# Agenda for 105<sup>th</sup> PCC Meeting

### AGENDA FOR 105<sup>TH</sup> PROTECTION COORDINATION SUB-COMMITTEE MEETING TO BE HELD ON 23.08.2021 AT 10:30 HOURS

Figure 4: SLD of 220kV BTPS-B S/S

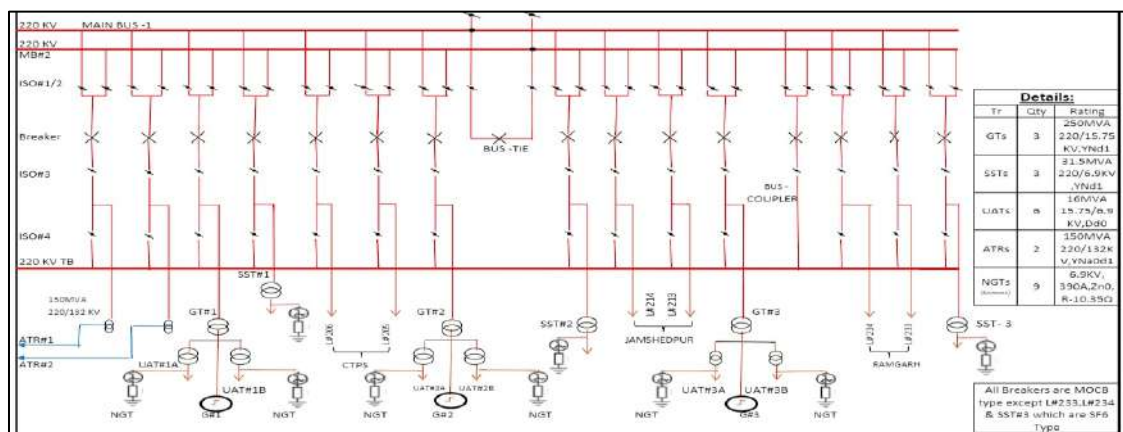
- Also, as reported one of the jumpers of L-55-132kV Ramgarh-Gola-1 got failed at Loc. No. 76.

Figure 3: PMU captured at Durgapur shows R-Y-Earth fault cleared in 100ms seconds and dip of around 35 kV.

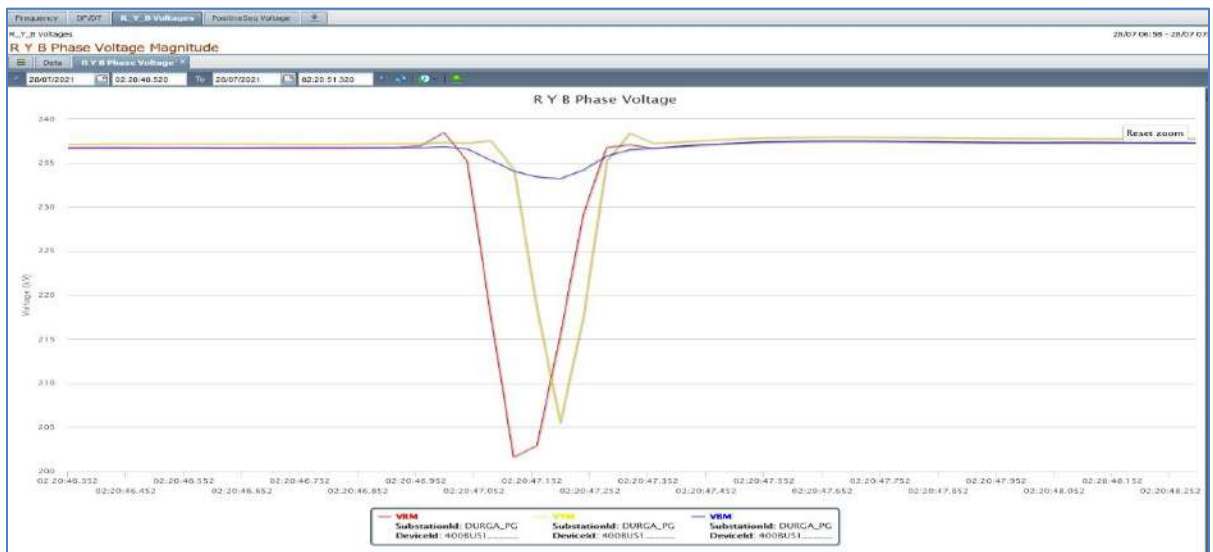
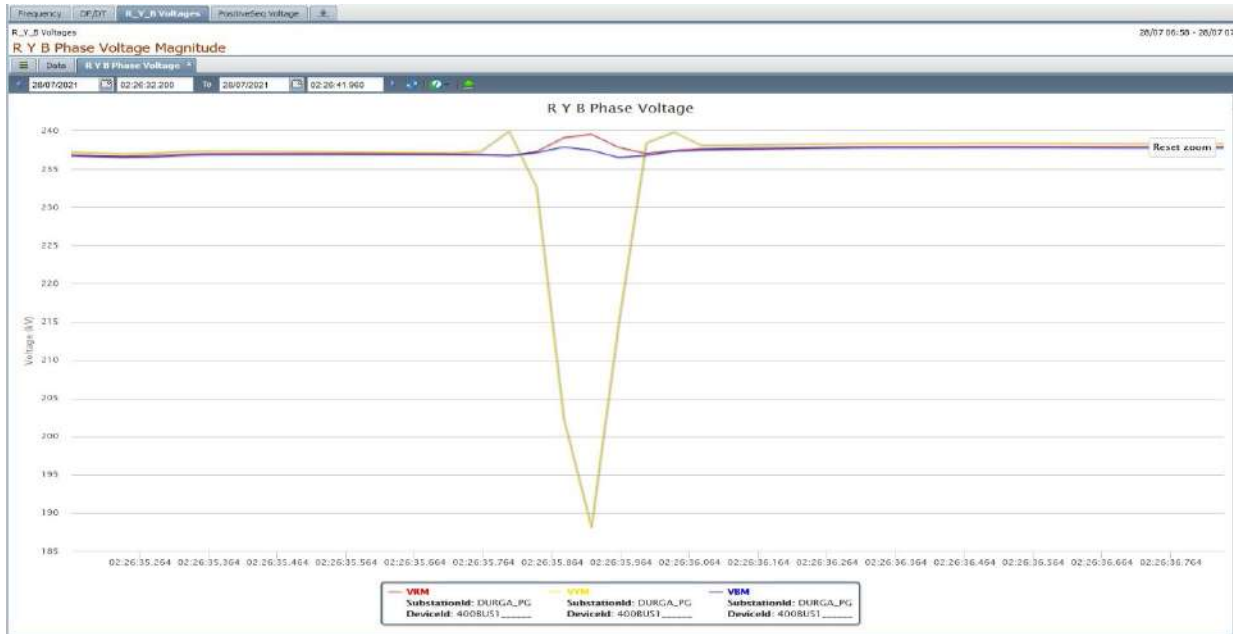
Unwanted tripping of 220 kVParulia (PG)- Parulia (DVC) through Back Up O/C Hi Set Protection was observed at PGCIL End , much before clearing of fault present in 220 kV Parulia -DSTPS line 2 from both ends in zone 1.

- This unwanted tripping had caused total loss of power at DVC Parulia SS which in turn caused blackout in three Oxygen plants at Durgapur and the captive power plant (SAIL).

- DVC has been conveyed that the Control & Protection system upgradation work under progress at 220KV Parulia DVC station and will be complete soon. Further upgradation planned for 220KV Durgapur-Parulia D/C Line with Fiber based Line differential Protection and likely to be executed in next 2-3 months.
- Considering above Powergrid ER-2 is going to disable the High Set O/C setting of 220KV lines. Simultaneously, we will reduce the Z2 timing of 220KV Lines from 350 mSec to 300 mSec.
- The ICTs at Durgapur station are very old and delayed fault clearing will reduce the equipment life. Hence requested to adhere the schedule timeline as commenced.

**DR recorded at MUSAHARI end for Darbhanga-Musahari-II:**

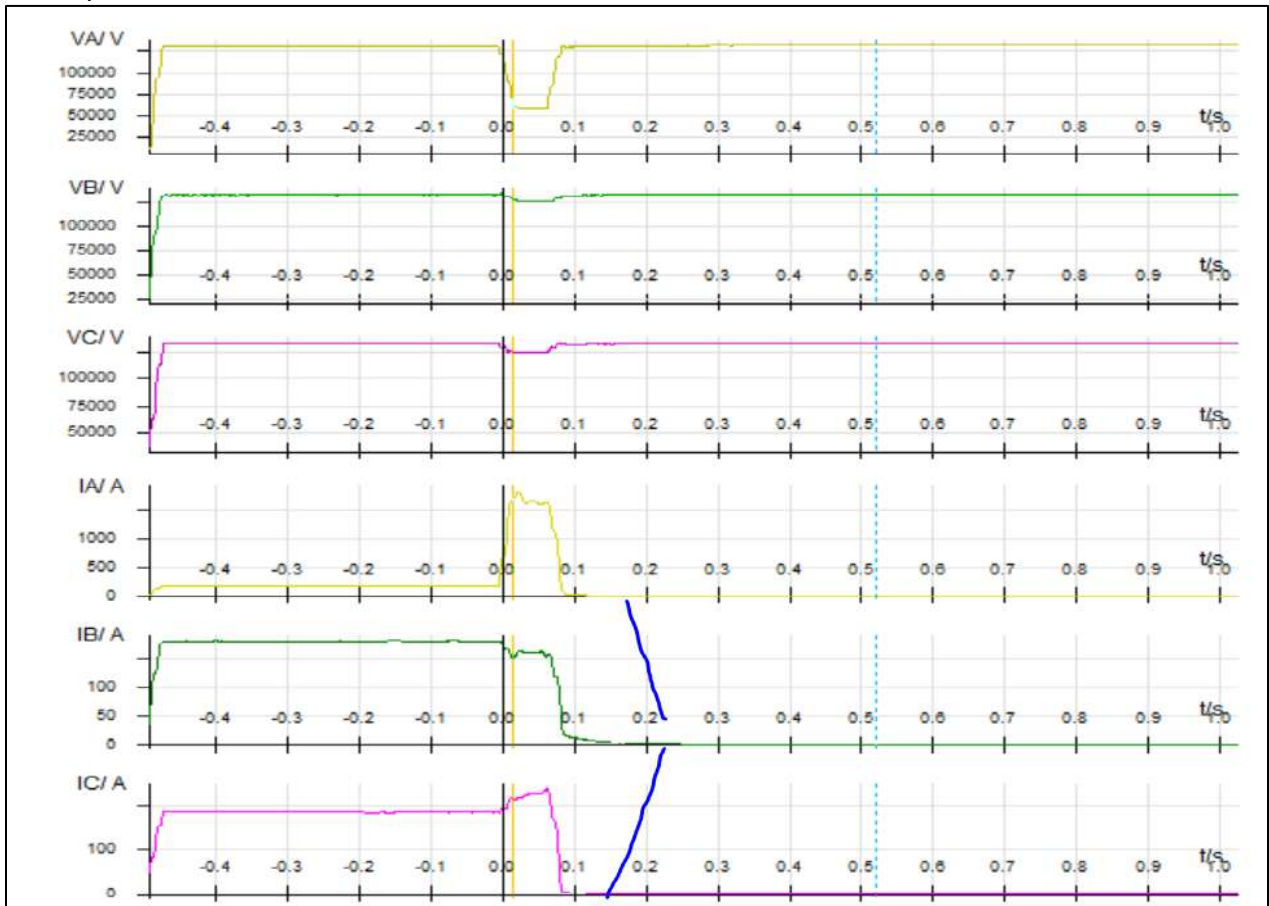
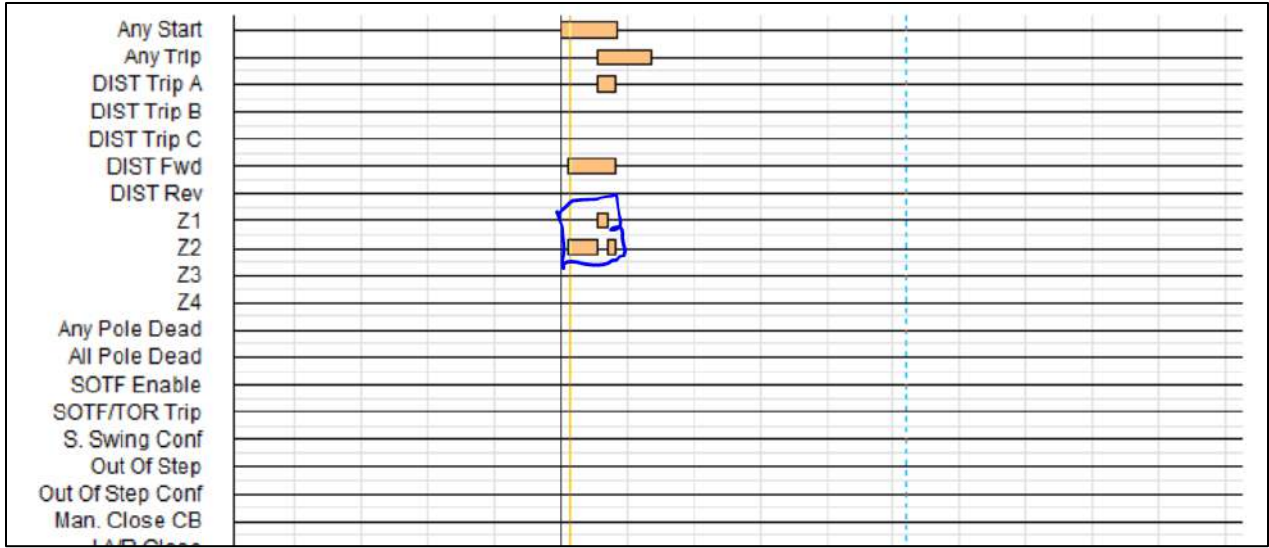
Three phase Current at Musahari end became zero

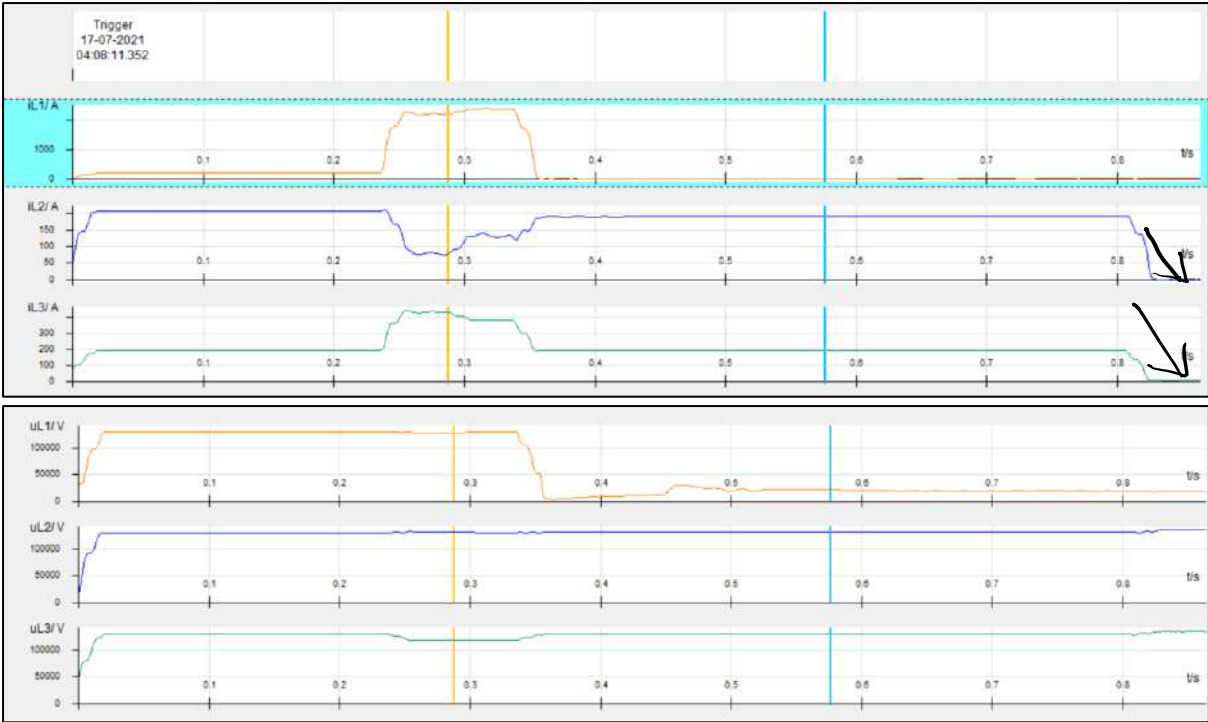
It has been observed that for all cases whenever there is fault in any phase , that phase is being opened immediately but after 500ms of that other rest two phases are also being opened as observed from Purnea end DR .

**Issue of Auto reclose** can also be seen in below attached DR that ,A/r is not occurring as rest 2 phases are being opened, this can be properly analysed for root cause identification and mitigation.

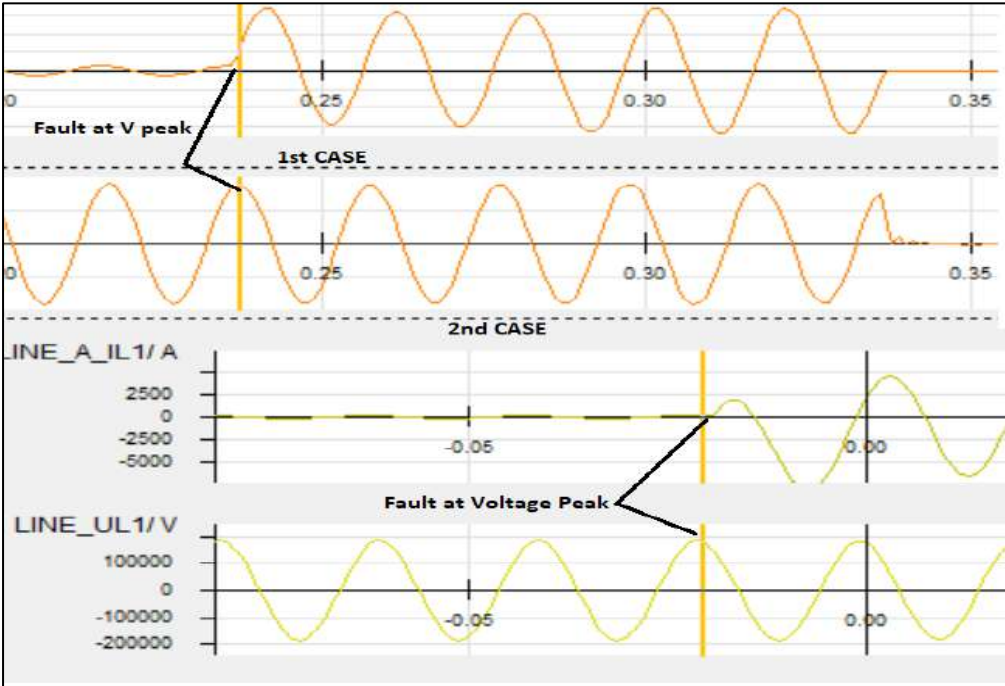
From DR signature analysis it is observed that in all cases, fault seems to be due to vegetation issue as all faults are occurring at voltage peak as arc over is occurring at voltage peak due to high electrical stress. Fault currents are symmetrical and have no Dc offset due to vegetation fault occurring at peak and with increasing nature of current.

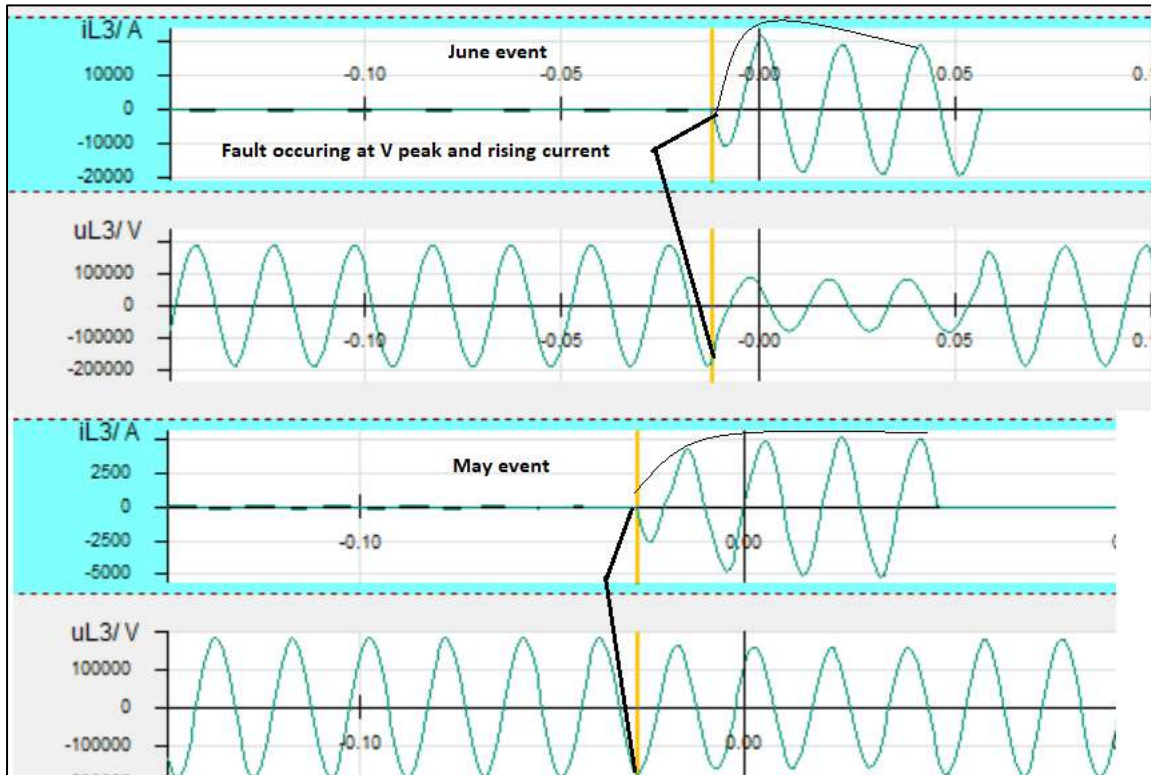
From DR signature analysis it is observed that in all cases, fault seems to be due to vegetation issue as all faults are occurring at voltage peak as arc over is occurring at voltage peak due to high electrical stress. Fault currents are symmetrical and have no Dc offset due to vegetation fault occurring at peak and with increasing nature of current.

All faults are of SLG nature ,DR attached below for both lines.
